APPEAL SUMMARY

Appeal ID: 19047	Project Address: 7633 N Wabash Ave
Hearing Date: 2/20/19	Appellant Name: Laurie Simpson
Case No. : B-016	Appellant Phone: 5033678057
Appeal Type: Building	Plans Examiner/Inspector: Connie Jones
Project Type: commercial	Stories: 1 Occupancy: E Construction Type: V-B
Building/Business Name: Escuela Viva	Fire Sprinklers: No
Appeal Involves: Alteration of an existing structure	LUR or Permit Application No.:
Plan Submitted Option: pdf [File 1] [File 2]	Proposed use: School

ESCUELA VIVA 7633 N Wabash Portland, OR 97217

EASEMENT EXHIBIT

1 EASEMENT DIAGRAM
1/16" = 1'-0"

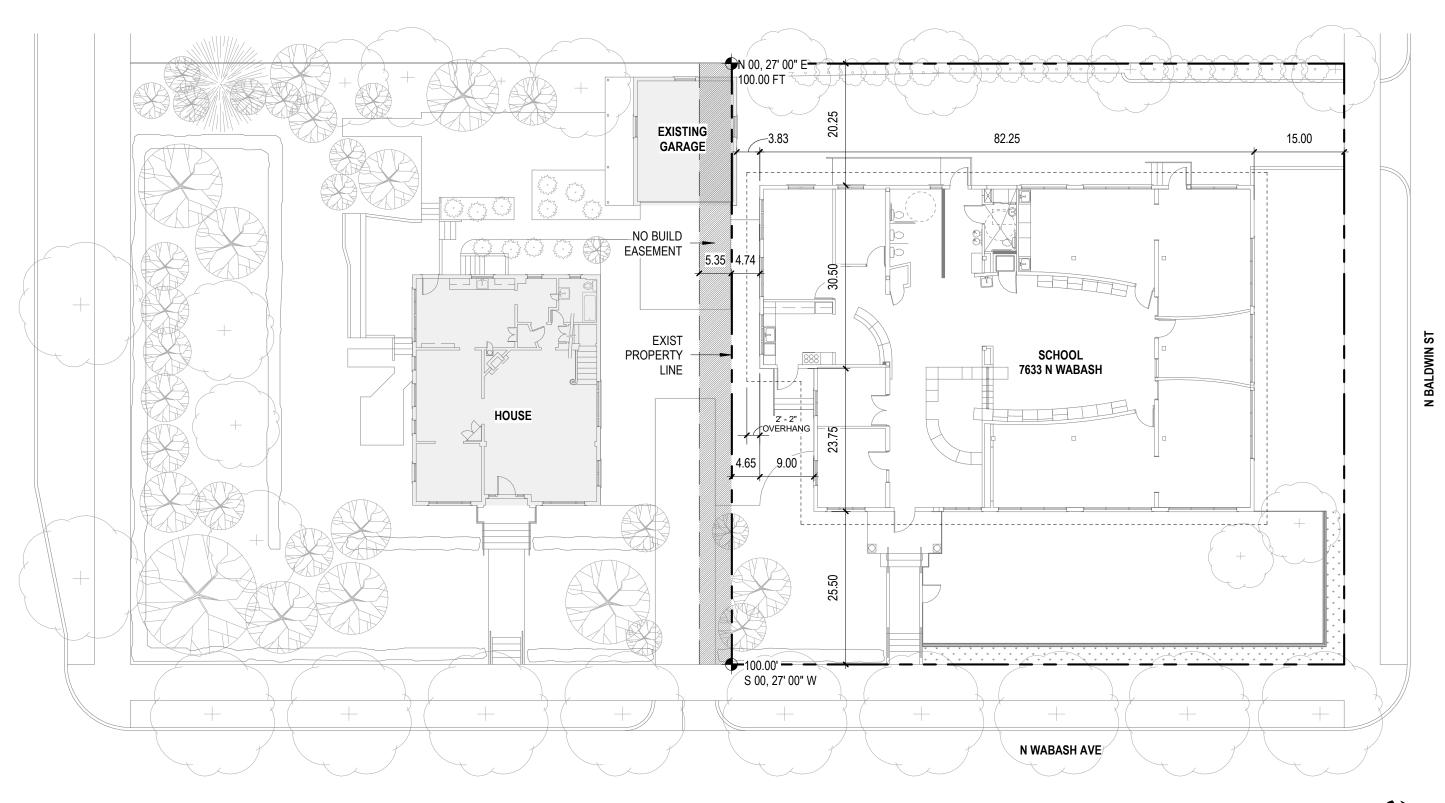
The existing south exterior wall is not fire rated and is located 4.65' from the existing south property line. For Type VB construction, the code would require a fire separation distance of 10' for a non-rated exterior wall. The school proposes a No-Build Easement that maintains a 10' nobuild zone, in lieu of fire rating the existing south exterior wall, in order to allow offices to convert to classrooms in the future. There is a 2'-2" eave projection within this fire separation distance, and 705.2 allows this projection into the 10' fire separation distance. Additionally, the adjacent property's existing garage encroaches 1.16' into the south edge of the school's property. The distance between the garage and the school building is 3.58'. In the event that the portion of the garage within the easement area is removed, this area will become part of the no-build zone and No build Easement. We are working with Nancy Thorington and Connie Jones on the final language of the easement.

An easement diagram is attached as well as a site/floor plan for reference. Nancy suggested the following sequence: submit the appeal, submit for permit, work on the easement

Reason for alternative The proposed alternate allows the existing building at 6670 N Wabash to remain if the school decides to convert office space to classroom space in the future. The no-build easement provides equivalent fire and life safety by providing a 10' no-build zone where a 10' fire separation distance would otherwise be required. The line used to determine the fire separation distance, will be created by the No-Build Easement as an assumed property line (to determine the fire separation distance) 5.35' south of the actual property line. This will provide 10 feet total between the school's south exterior wall and the edge of the No-Build Easement, which includes a 2'-2" projection from the school's south exterior wall.

Omission of fire rated exterior wall with no-build easement: Hold for additional information. Appellant may contact John Butler (503 823-7339) with questions.
